## CHANGE ORDER

<b>CONTRACT:</b>	<u>Downtown Corridor Roadway Improvements</u>	<b>CHANGE ORDER NO:</b>	<u>2</u>
<b>CONTRACTOR:</b>	<u>Quality Enterprises USA, Inc.</u>	<b>BID NO:</b>	<u>3084-18</u>
	<u>3494 Shearwater Street</u>	<b>PROJECT NO:</b>	<u>GO17R3</u>
	<u>Naples, FL 34117-8414</u>	<b>CONTRACT DATE:</b>	<u>05/08/2018</u>

Install conduit installation for future video camera install by others.

### CONDUIT AND CONDUCTOR FOR FUTURE VIDEO CAMERAS BY OTHERS

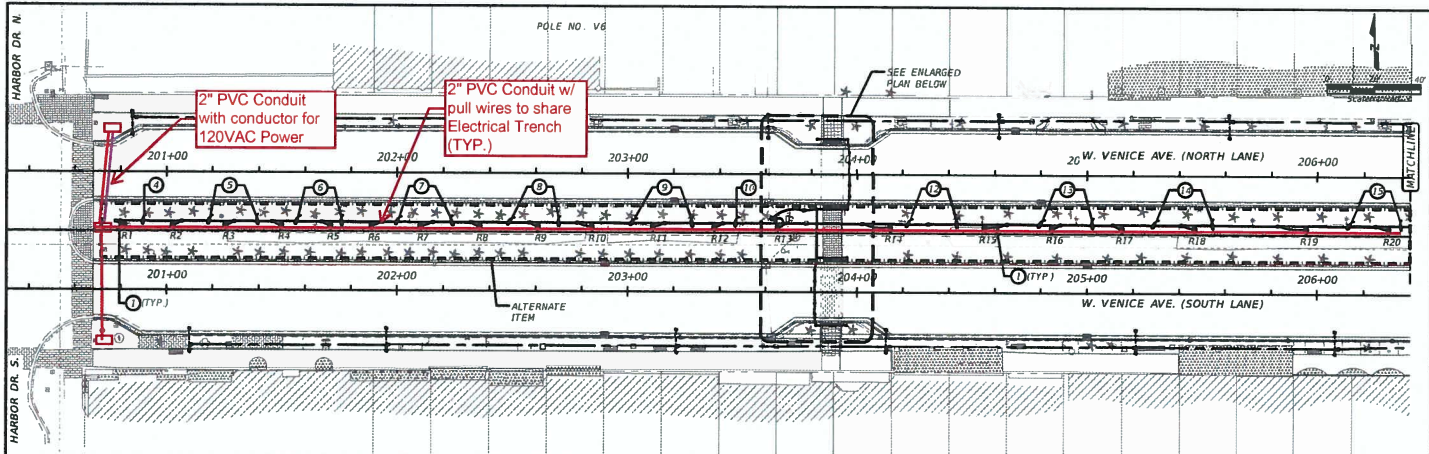
PAYITEM	DESCRIPTION	QUANTITY	UNIT	UNIT PRICE	SUB-TOTAL
630 2 11	CONDUIT, (F&I), OPEN TRENCH	2,056.00	LF	7.00	14,392.00
630 2 11	CONDUIT, (F&I), W-CONDUCTOR	286.00	LF	10.00	2,860.00
635 2 11	PULL & JUNCTION BOX, 13X24X12	8.00	EA	650.00	5,200.00
635 2 12	PULL & JUNCTION BOX, 24X36X24	4.00	EA	1,250.00	5,000.00
TOTAL PROPOSAL PRICE \$					27,452.00
